ED Data Request 01-SDGE Response
A.17-06-029 SDG&E Tie Line 674A Reconfiguration and TL 666D Removal Project (Proposed Project)
Data Request 01 Dated November 9, 2017

Key Observation Point 11
View of the Proposed Project from Via Sorrento Parkway looking southeast
See Figure 4.1-1 for viewpoint location

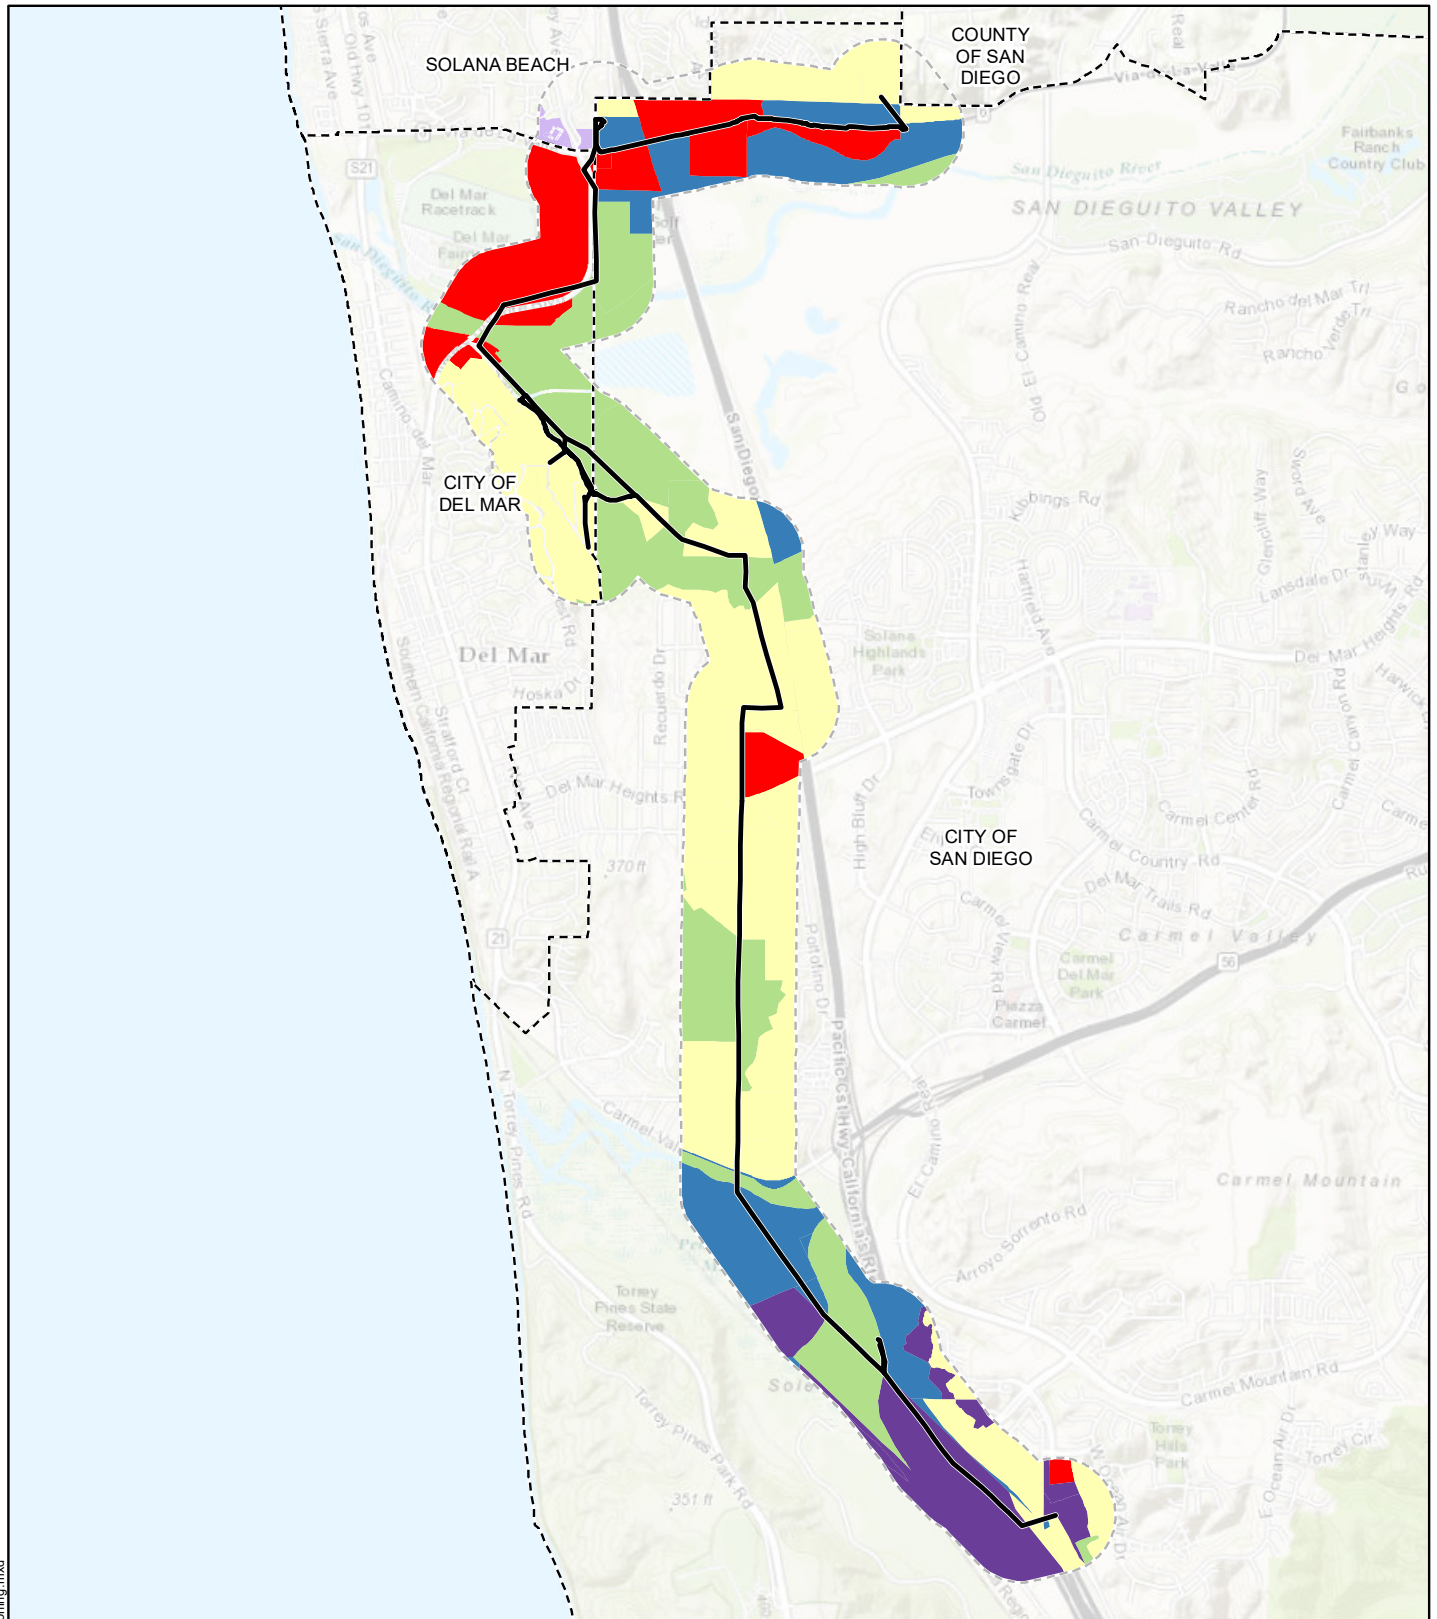
Section/Q#	Description	San Diego Gas & Electric Company (SDG&E) Response
AES-3 PEA Attachment 4.1-B	Provide a visual simulation from the portion of the I-5 highway that is eligible for designation, or show within the existing simulations where this area of the highway would be designated.	<p>The motorist view along Interstate (I-) 5 was originally considered for a KOP due to the designation eligibility; however, the photo documentation process was deemed unsafe in this location. This determination was made due to the high vehicle speeds and minimal shoulder along this section of I-5.</p> <p>Additional viewpoints that are similar to those from I-5 were investigated. This included reviewing potential overpasses perpendicular to I-5 and roads parallel to I-5. In the vicinity of the existing TL666D crossing, there are no existing overpasses. Sorrento Valley Road is located at a lower elevation than I-5; therefore, photography from this location will not represent the view of motorists on I-5. Vista Sorrento Parkway, also adjacent to I-5, provides a view of Pole 106 and was used as the basis for KOP 11. The simulation from KOP 11 has been modified to depict the portion of I-5 that is visible from this location and is included as Attachment B: Annotated Visual Simulation.</p>
